**SP-22-00028:** A site plan for the Stratford Water Tower for the construction of a new approximately 140-foot tall water tower and the demolition of the existing water tower, located at 1225 Sunset Drive. Submitted by the City of Lawrence, property owner of record.

**ADMINISTRATIVE DETERMINATION:** The Planning Director approves the above-described Site Plan.

**Figure 4.** Current proposed site plan

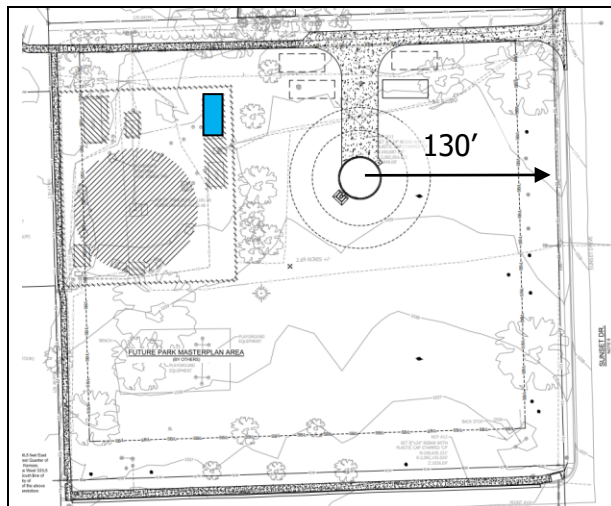
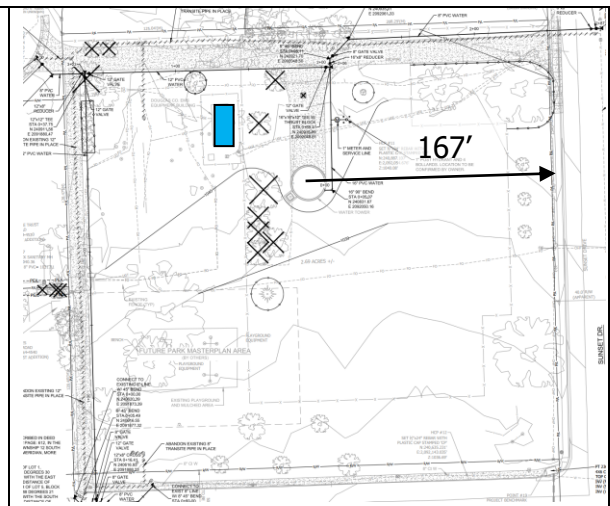
**Condition b:** The owner/applicant shall submit to Planning Staff a revised site plan, locating the proposed water tower 30 to 37 feet to the west of the northcentral location presented to the Governing Body at its December 1, 2020, public meeting.

**Staff Response:** The site plan shows the building setbacks applicable to the district. Within the building envelop an additional structure setback was imposed by the City Commission. The revised site plan shows the location of the proposed tower located an additional 37 feet to the west providing an increased setback from Sunset Drive.

**Condition f:** The existing Douglas County Emergency Communications building shall be reused or relocated, if possible, on the west side of the proposed water tower.

**Staff Response:** The site plan shows the location of the existing building on the west side of the new tower. The building will be reused as equipment is upgraded and/or moved from the existing water tower to the new water tower. Figure 4 shows the retention of the building and the addition of ornamental fencing around that structure.

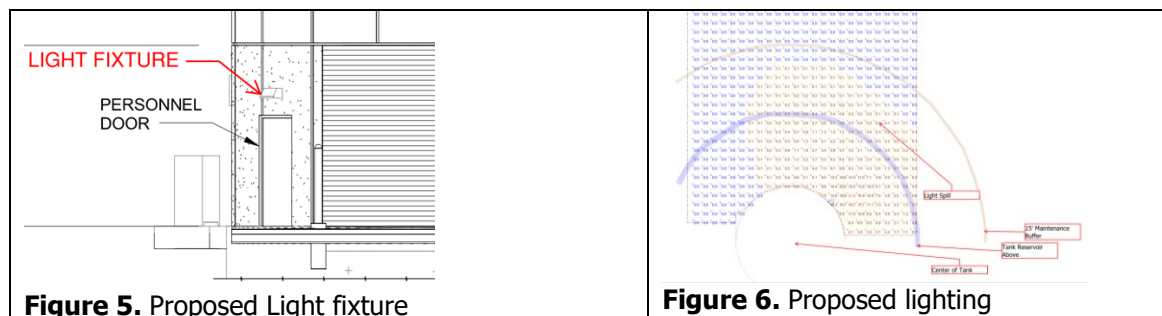
The north access is designed with a three-foot wide stamped concrete border with an earth-tone color on each side of the East/West multi-use path/access drive. The total width of the drive will be 16 feet, per modified fire code regulations. The center section is wider to accommodate emergency apparatus.

The access drive running north/south directly to the tower will be entirely stamped concrete in the earth-tone color. The specific color to be used will be detailed in the construction documents. A rollback curb will be used at the east and west entrances of the access drive. The bollards at either end of the drive will be collapsible.
